Title - Sujet Sinclair Centre Revitalization Ph.1	
Solicitation No. - N° de l'invitation EZ899-132937/A	Amendment No. - N° modif. 006
Client Reference No. - N° de référence du client	Date 2013-02-26
GETS Reference No. - N° de référence de SEAG PW-\$PWY-020-6918	
File No. - N° de dossier PWY-2-35326 (020)	CCC No./N° CCC - FMS No./N° VME
Solicitation Closes - L'invitation prend fin at - à 02:00 PM on - le 2013-03-01	Time Zone Fuseau horaire Pacific Standard Time PST
F.O.B. - F.A.B. Plant-Usine: <input type="checkbox"/> Destination: <input checked="" type="checkbox"/> Other-Autre: <input type="checkbox"/>	
Address Enquiries to: - Adresser toutes questions à: Ly, Ronny(PWY)	Buyer Id - Id de l'acheteur pwy020
Telephone No. - N° de téléphone (604) 666-0043 ()	FAX No. - N° de FAX (604) 775-6633
Destination - of Goods, Services, and Construction: Destination - des biens, services et construction: PWGSC - Sinclair Centre, Vancouver, BC

Please find Addendum #4 herein.

1.0 DRAWINGS – MECHANICAL

**SINCLAIR CENTRE
REVITALIZATION - PHASE 1**

LEONE GAS SUPPLY

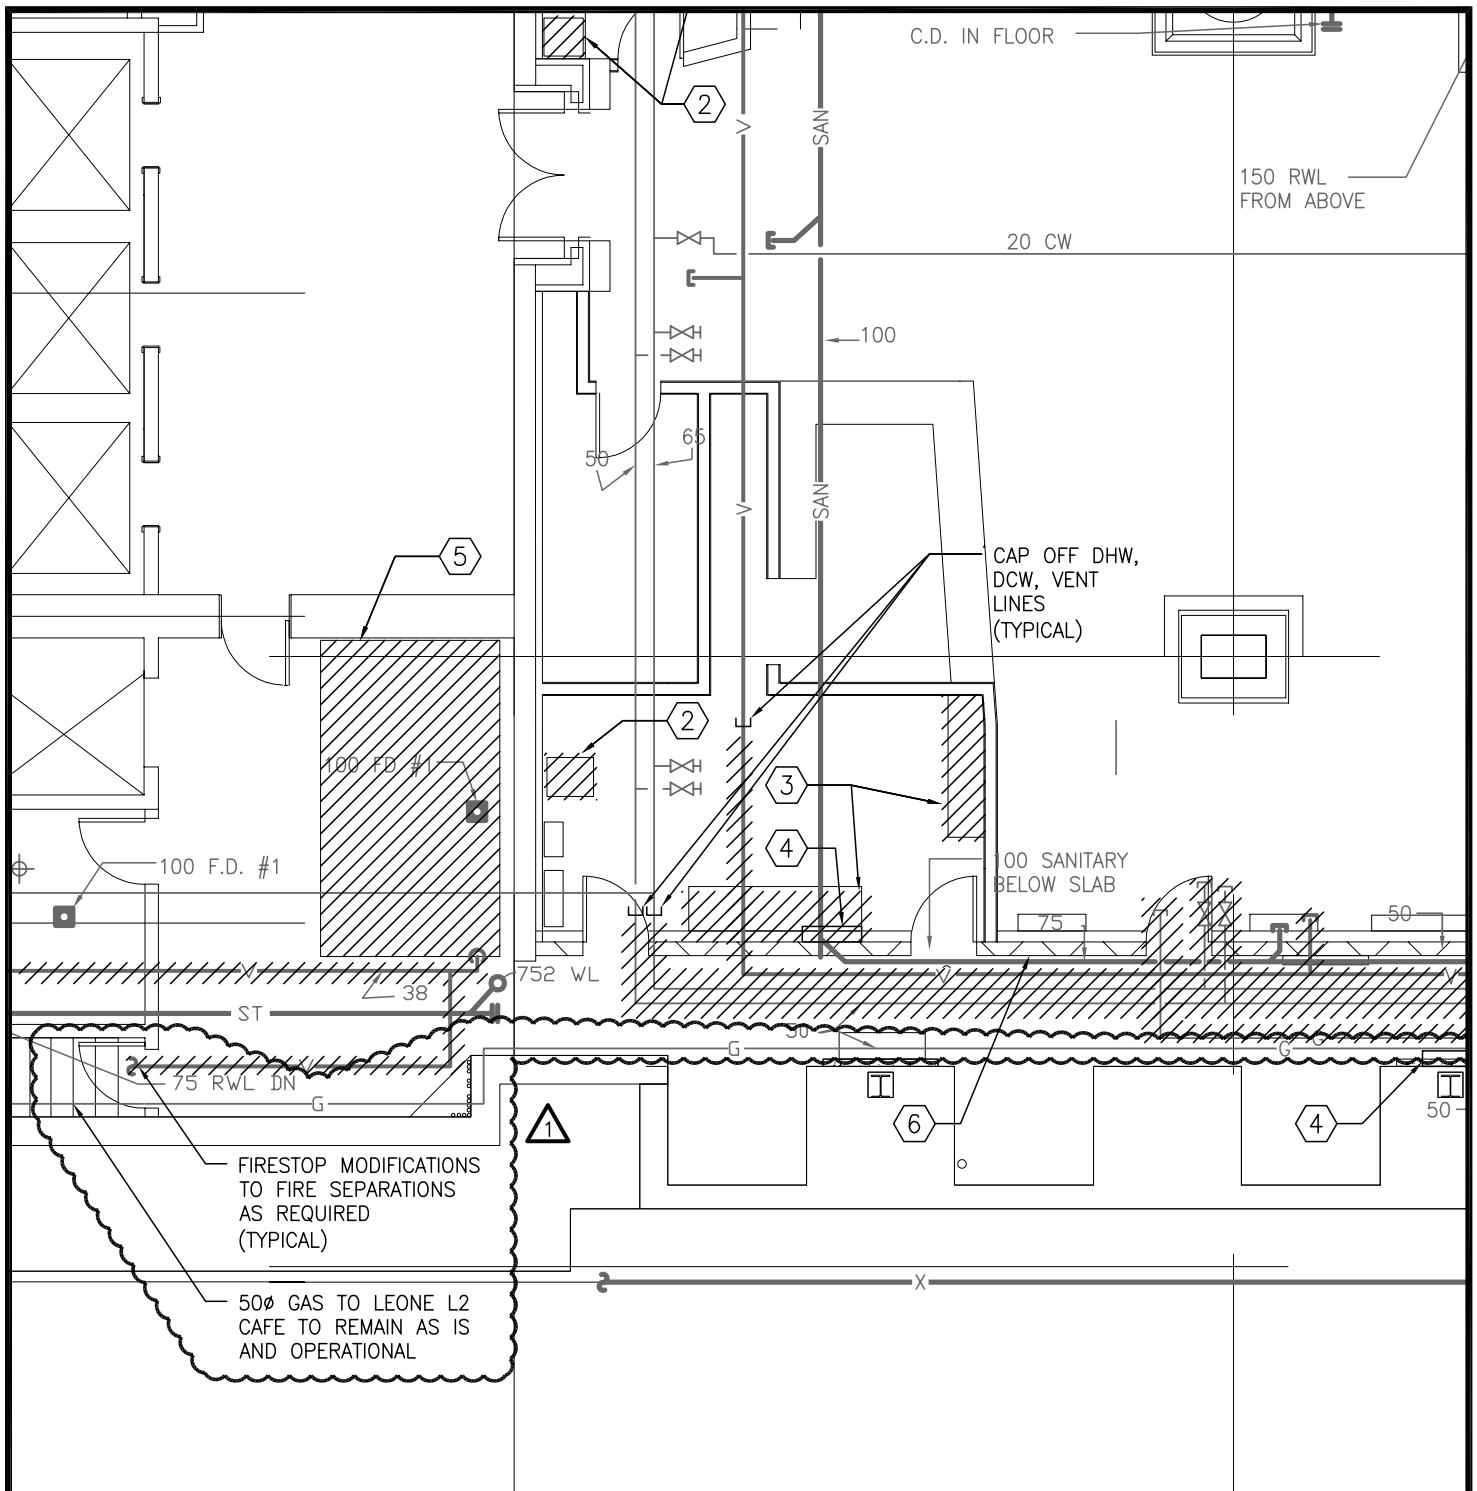
1.1 DRAWING NO. M1.01 Plumbing Demolition Post Office Level B1

REVISE: 50Ø gas line, and associated gas meter, fittings, trim, etc., serving L2 Cafe in Leone's B1 area, to remain as-is (see attached sketch). Leone L2 Cafe gas supply to remain operational throughout demolition. If any temporary disruption to gas service is required to perform scope of work, contractor to inform and coordinate with L2 Cafe to avoid disruption of cafe operations. All other gas lines to be deleted as indicated on the previously issued 'Issued for Tender' drawings.

DRAWING TITLE
**LEONE KITCHEN
EXHAUST**

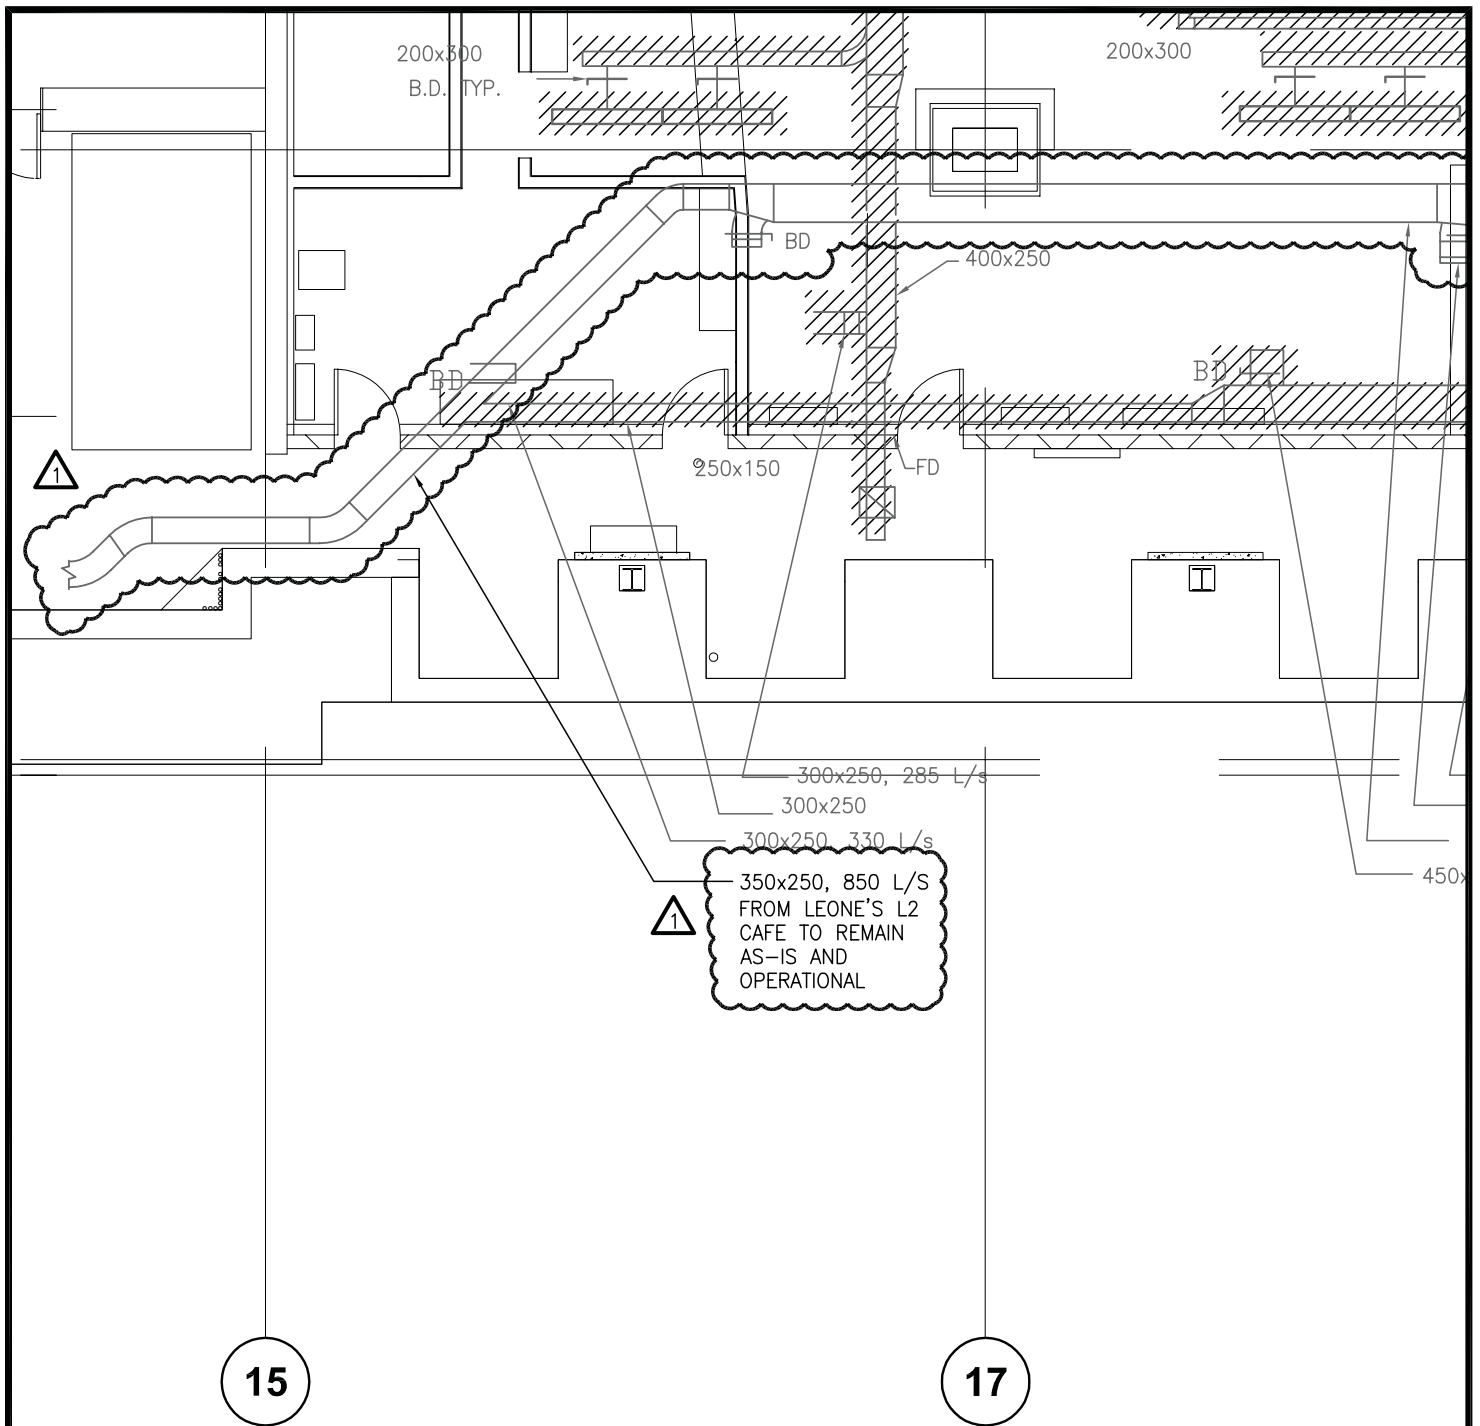
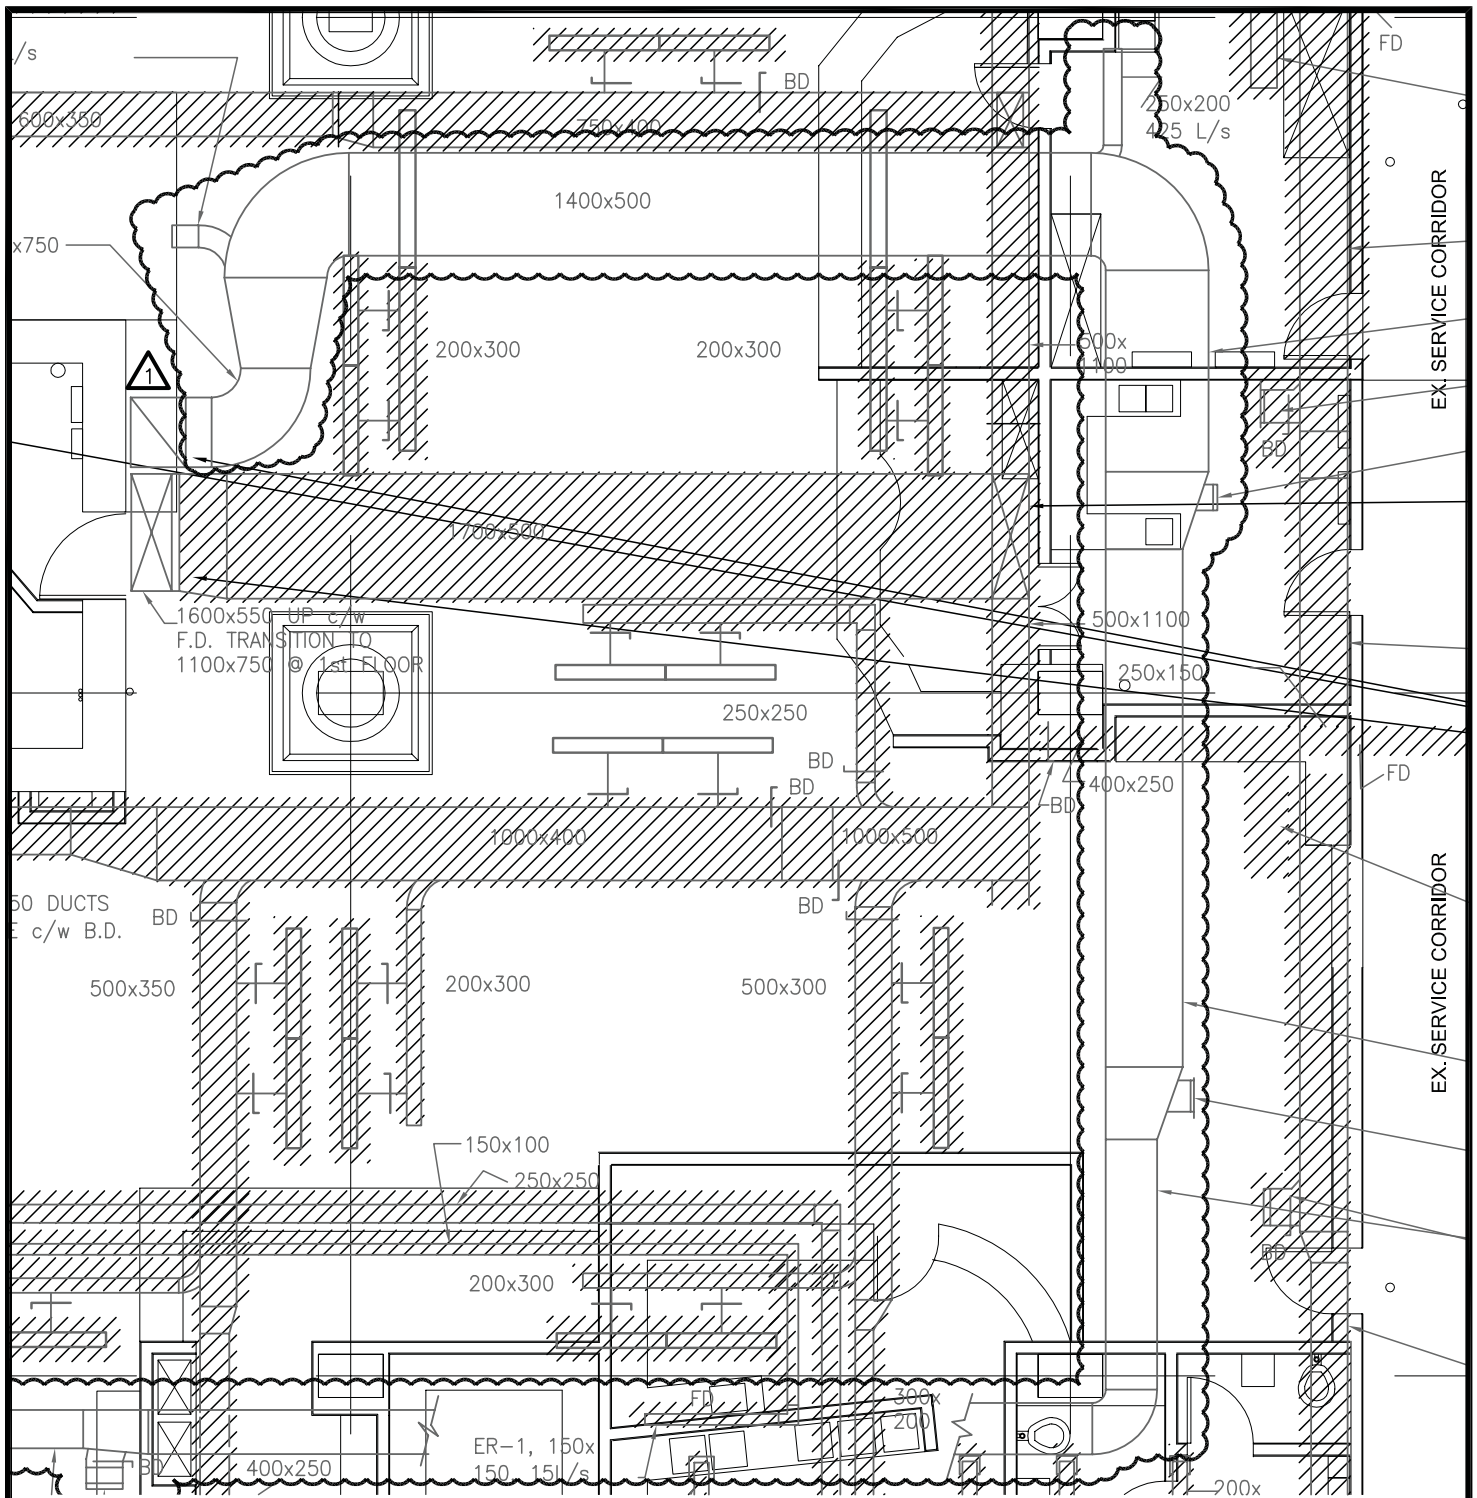
1.2 DRAWING NO. M2.01 HVAC Demolition Post Office Level B1

REVISE: 350x250 exhaust air ductwork, and associated ductwork leading to kitchen exhaust air riser, serving L2 Cafe in Leone's B1 area, to remain as-is (see attached sketch). Kitchen exhaust to remain operational throughout demolition.
